M98-1121 - PANYNJ

IWTC 92 FL

To: Ms. Teresa Koebel, Manager, World Trade Project Management
From: C. John Lin, P.E.
Date: August 31, 1998
Subject: **WTC - ALTERATION APPLICATION W-981121 - PANYNJ - 1 WTC, 92ND FLOOR - CORRIDOR AND LOBBY UPGRADE**

Facility One FLR 92nd TAA No. 98121 Date 8/24/98

A/A1

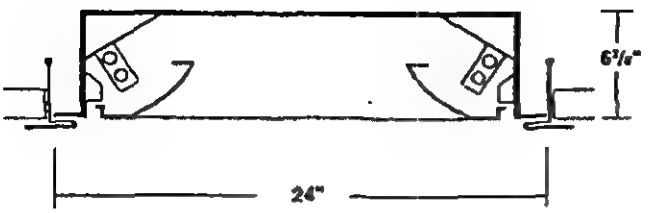
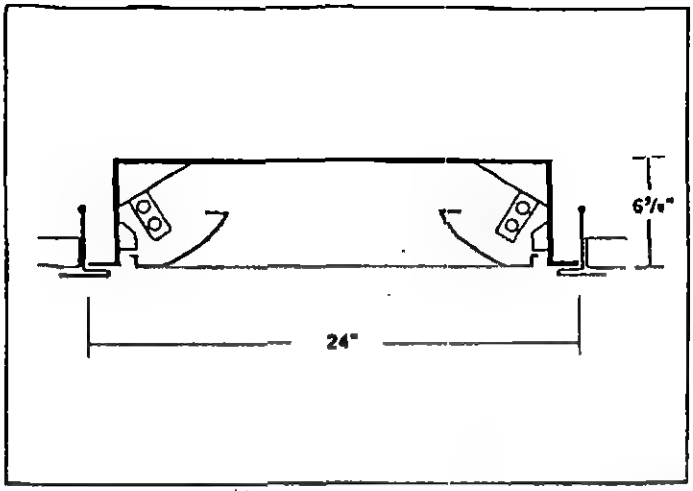
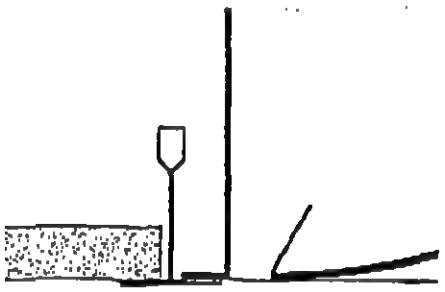
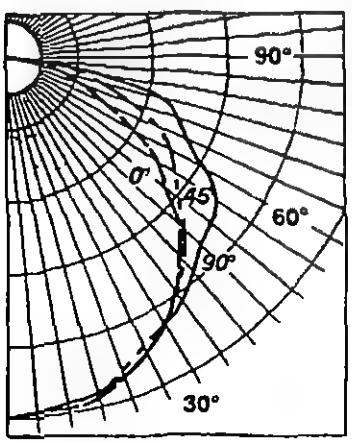
i) Submit the photometric data for each type of emergency fixtures used, including a typical candlepower distribution curve for each. See Figure 10.3.

Response to 2.b See enclosed submissions of photometric data for each type of emergency fixture including typical candlepower, and distribution curve

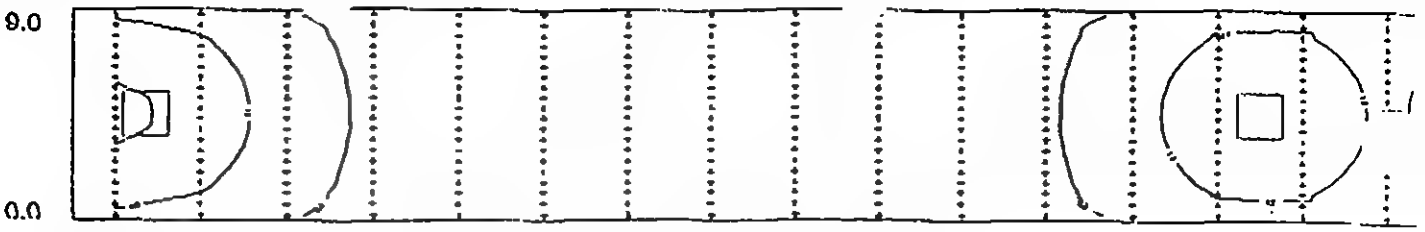
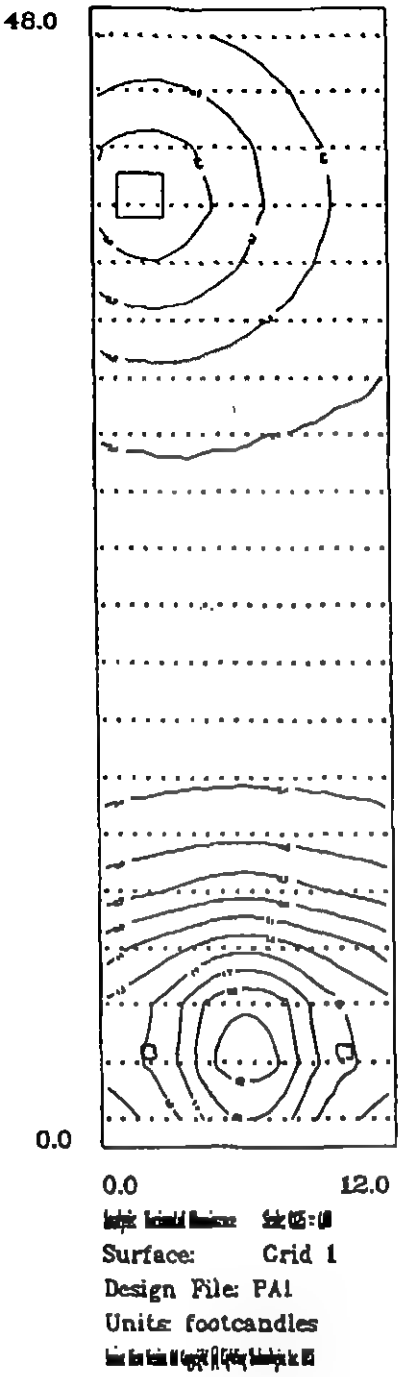
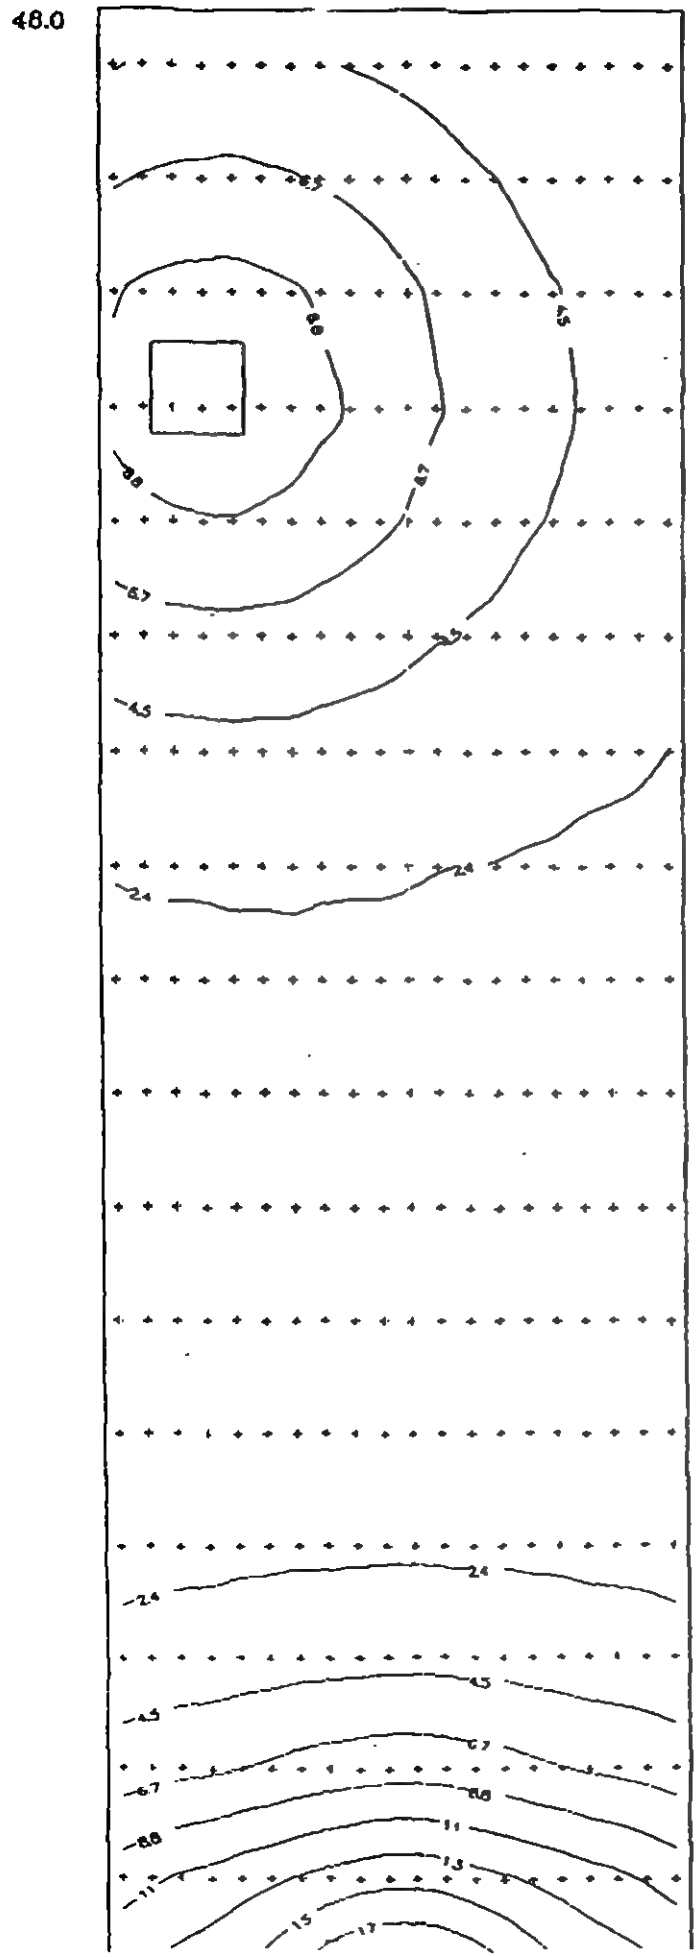
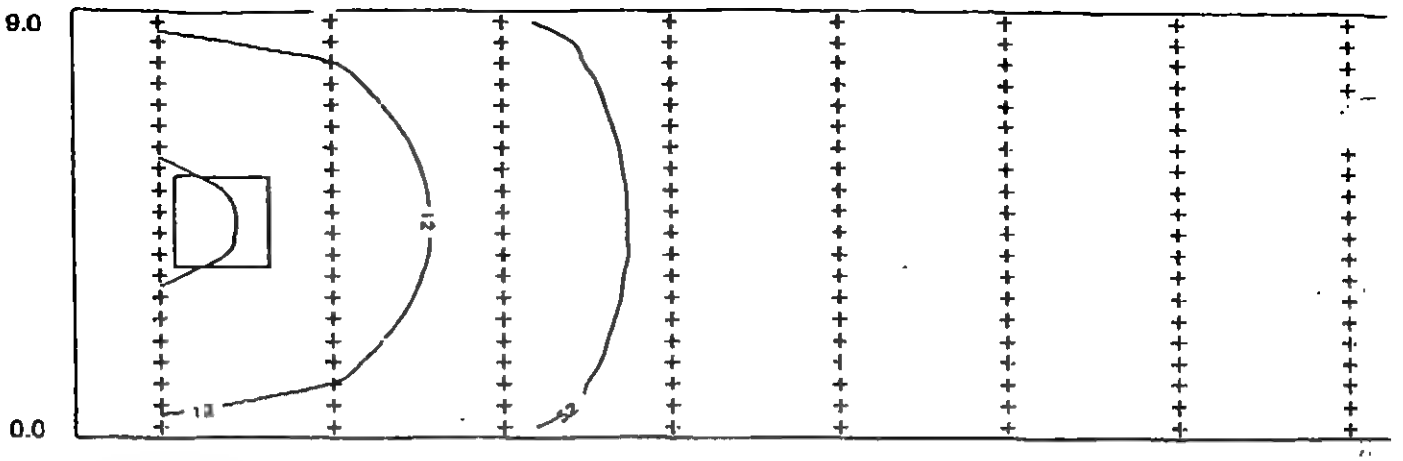
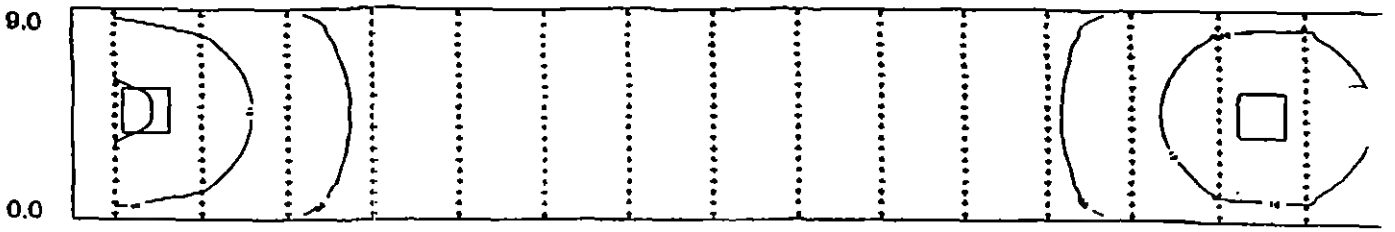
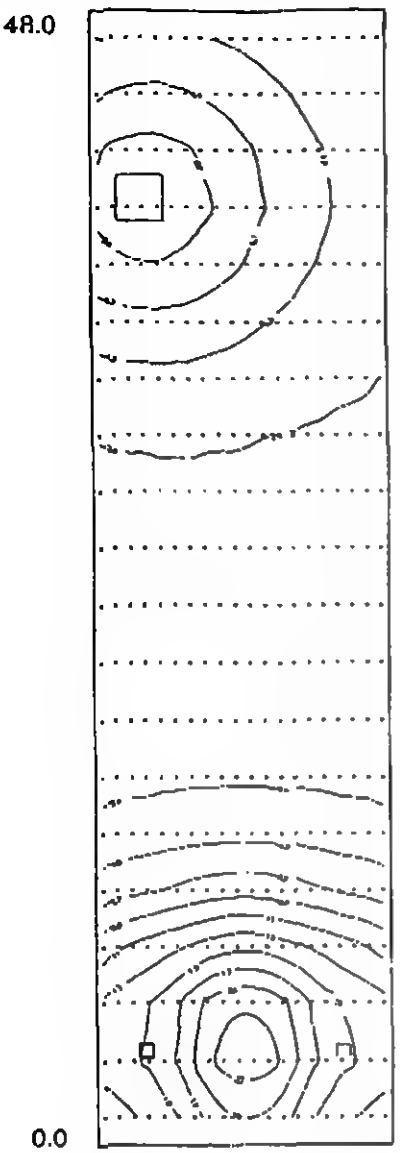
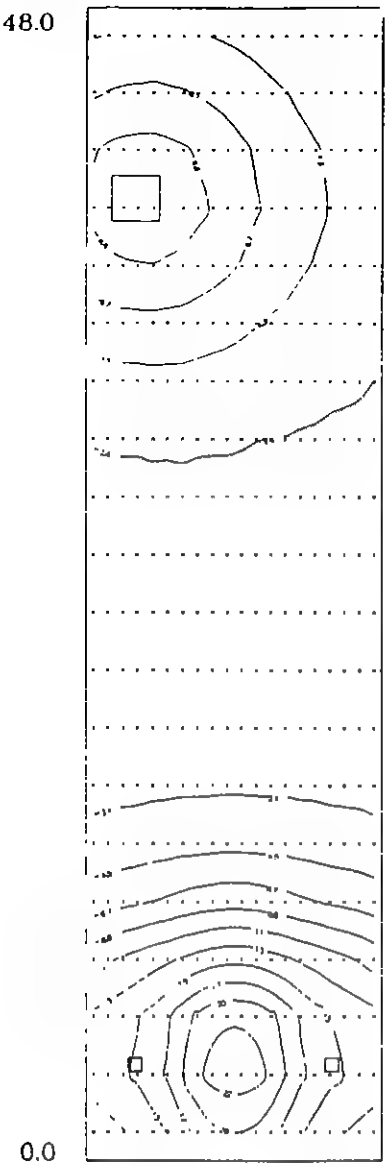
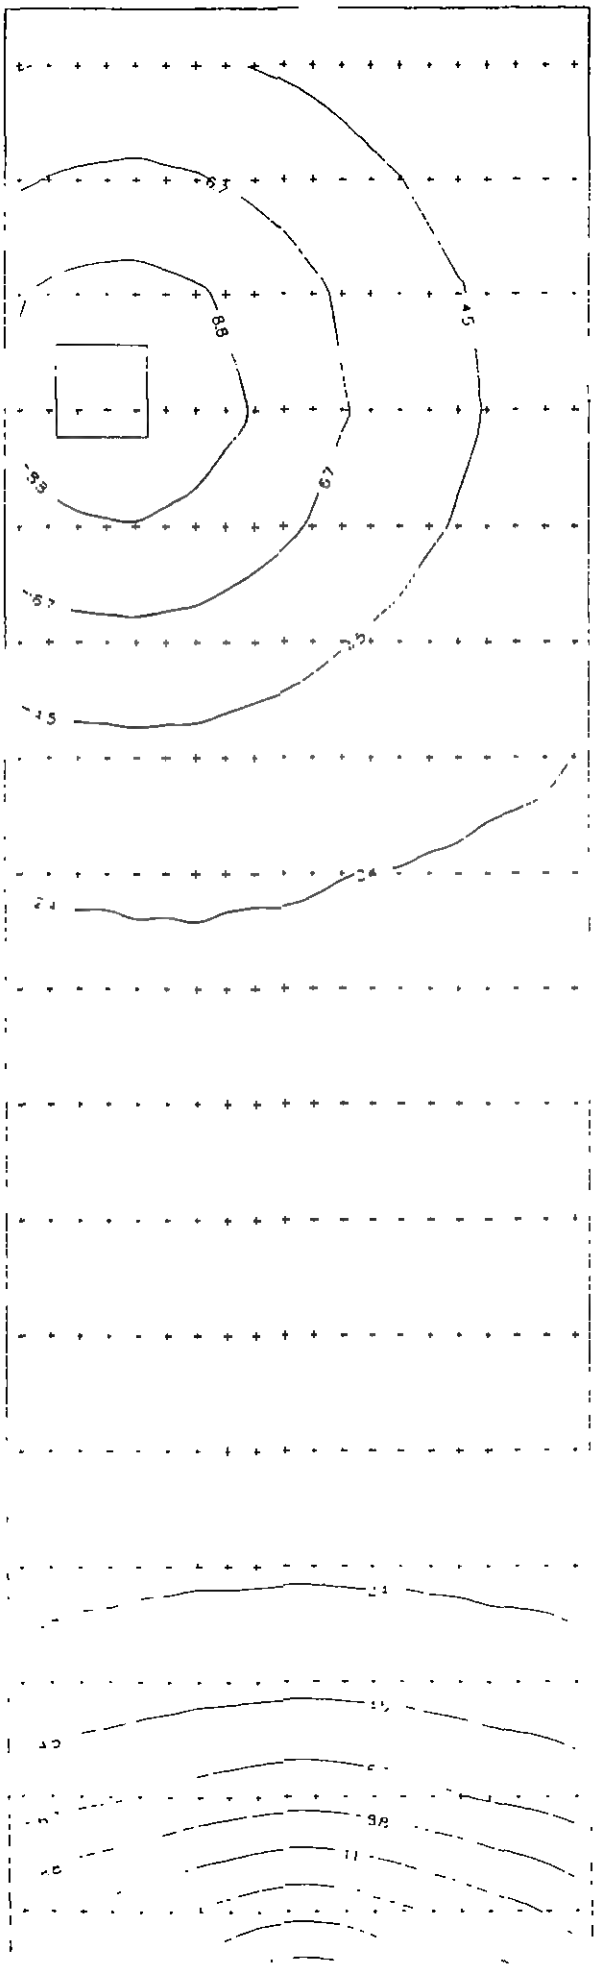
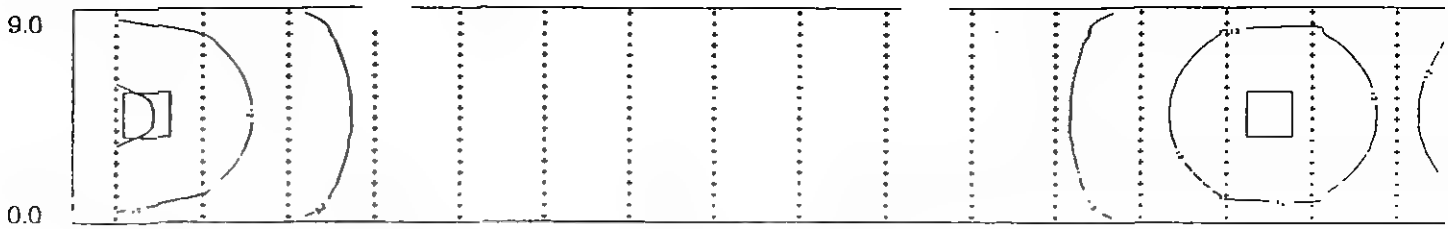
a) EXHIBIT 3 shows an average illumination of 12.9 fc and a minimum of 2.07 fc but EXHIBIT 1 and EXHIBIT 2 show that the levels of illumination drops to zero (no levels of illumination are shown) between the emergency fixtures.

Please clarify, and submit printout ot levels of illumination similar to EXHITIT 3, but under emergency condition with the average and minimum levels of illumination indicated.

Response to 2.a See enclosed calculations the footcandle levels do not drop to 0 they remain at 2.4 no additional curves indicate constant reading.

Drawing Number E192C

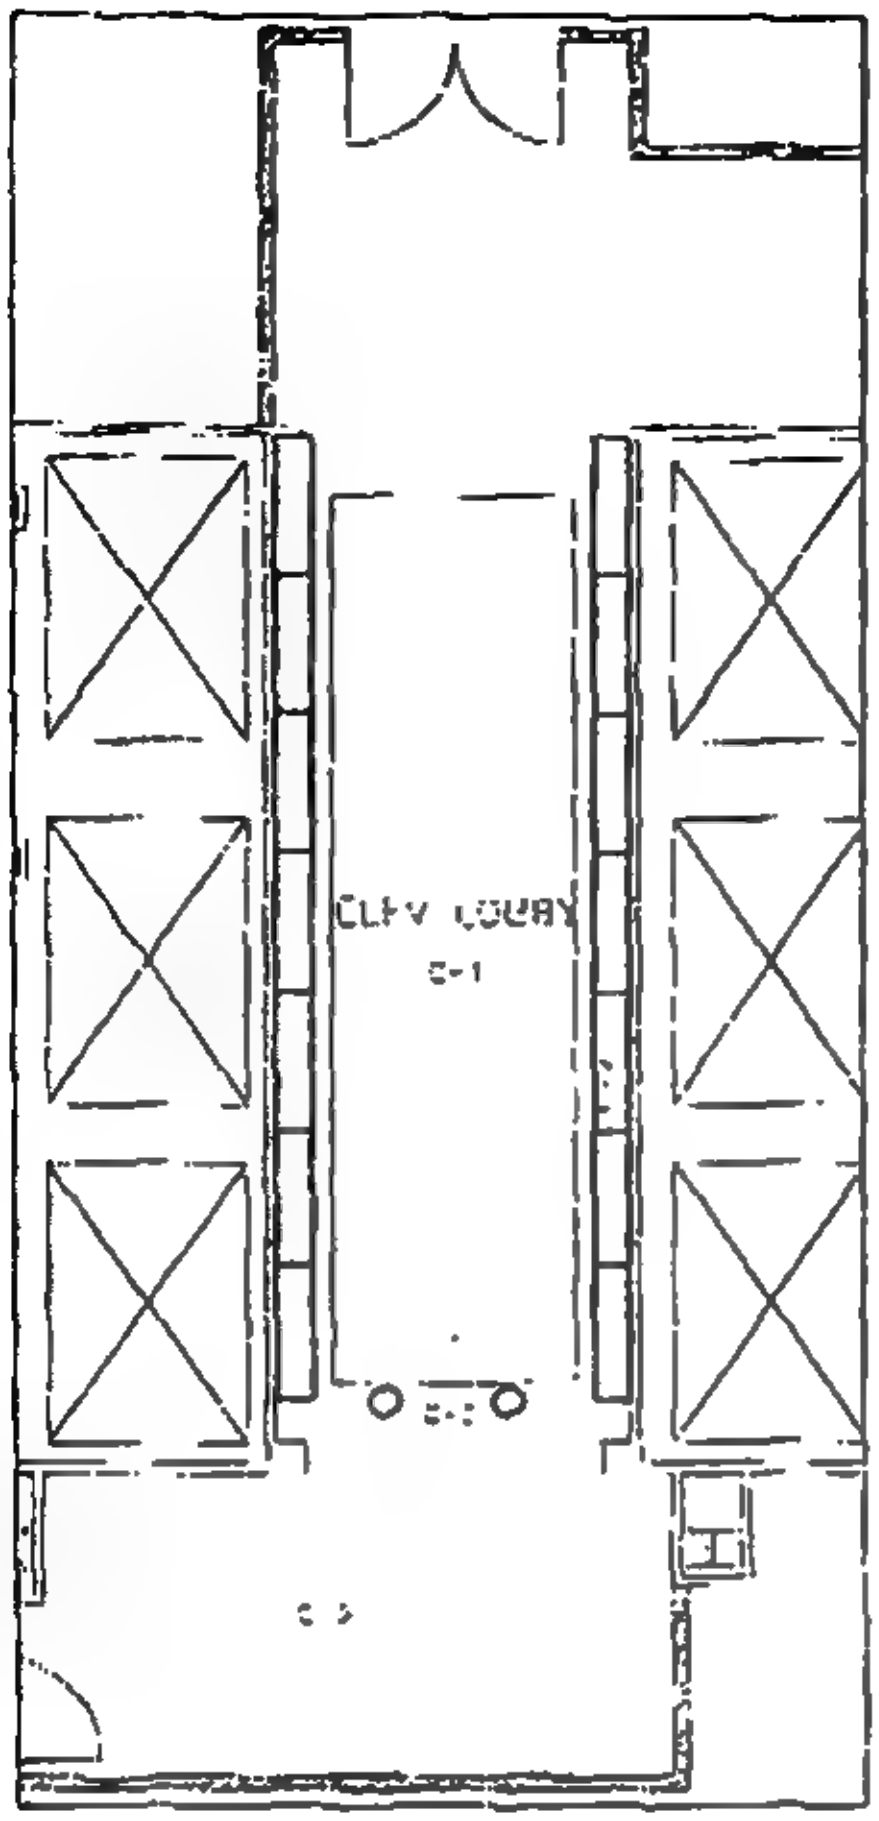
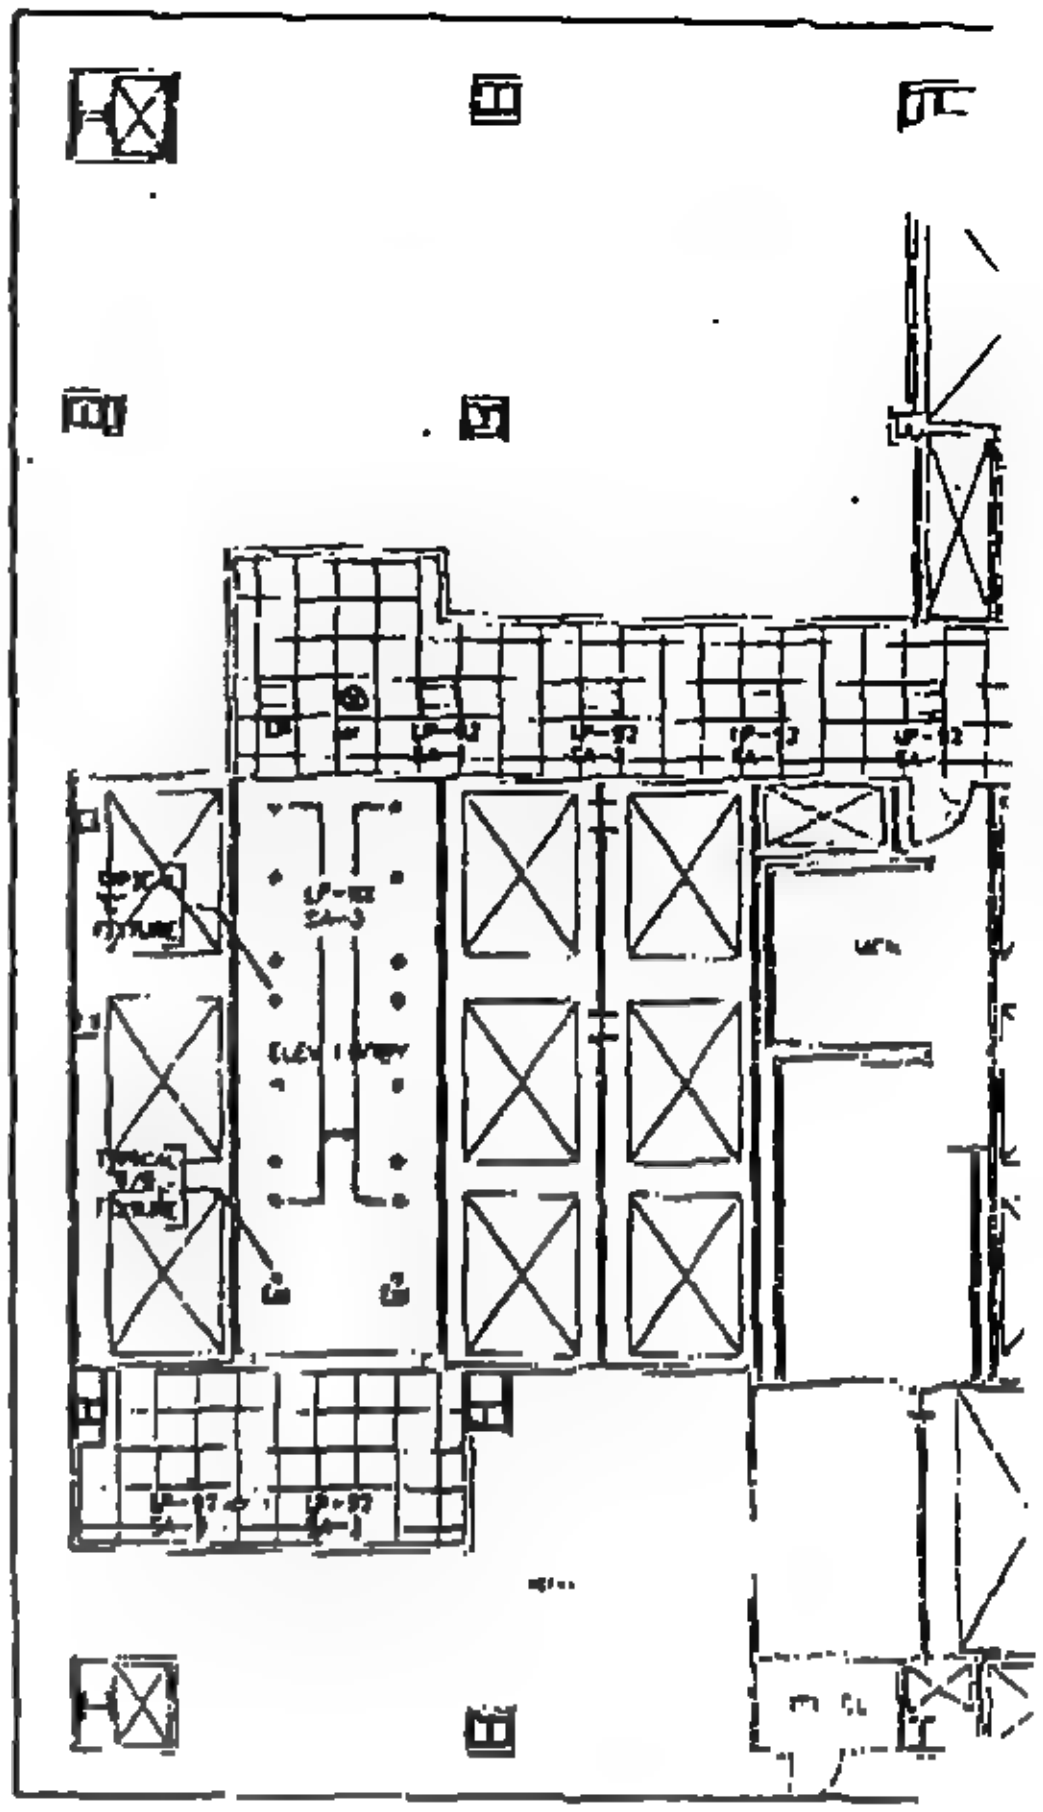
2. DRAWING E192C. The response to Comment 1 of the previous Rider is noted. Two (2) printouts of iso footcandle curves, Design File PA1 (EXHIBIT 1) and Design File PA2 (EXHIBIT 2) representing the Elevator Lobby and the Corridor, respectively, were submitted. Also submitted is a printout Design File PA2.des herein designated as EXHITIT 3) showing levels of illumination along the Corridor during normal conditions

c) On Drawing (E192C), show the specific type of fixtures to be used. The emergency fixtures are designated as B/B1 and A/A1. Please be specific.

Response to 2.c Drawing was corrected also enclosed is a catalogue cut of fixture intended to be used. Fixtures are designed for 120V on the lighting fixture list. Typical A-1 and B-1 fixtures are indicated on the plan. Emergency fixtures are indicated on the plan and the notes require all said fixtures to be wired for 120V . The A-1 and B-1 fixtures are those which are designated as Emergency fixtures.
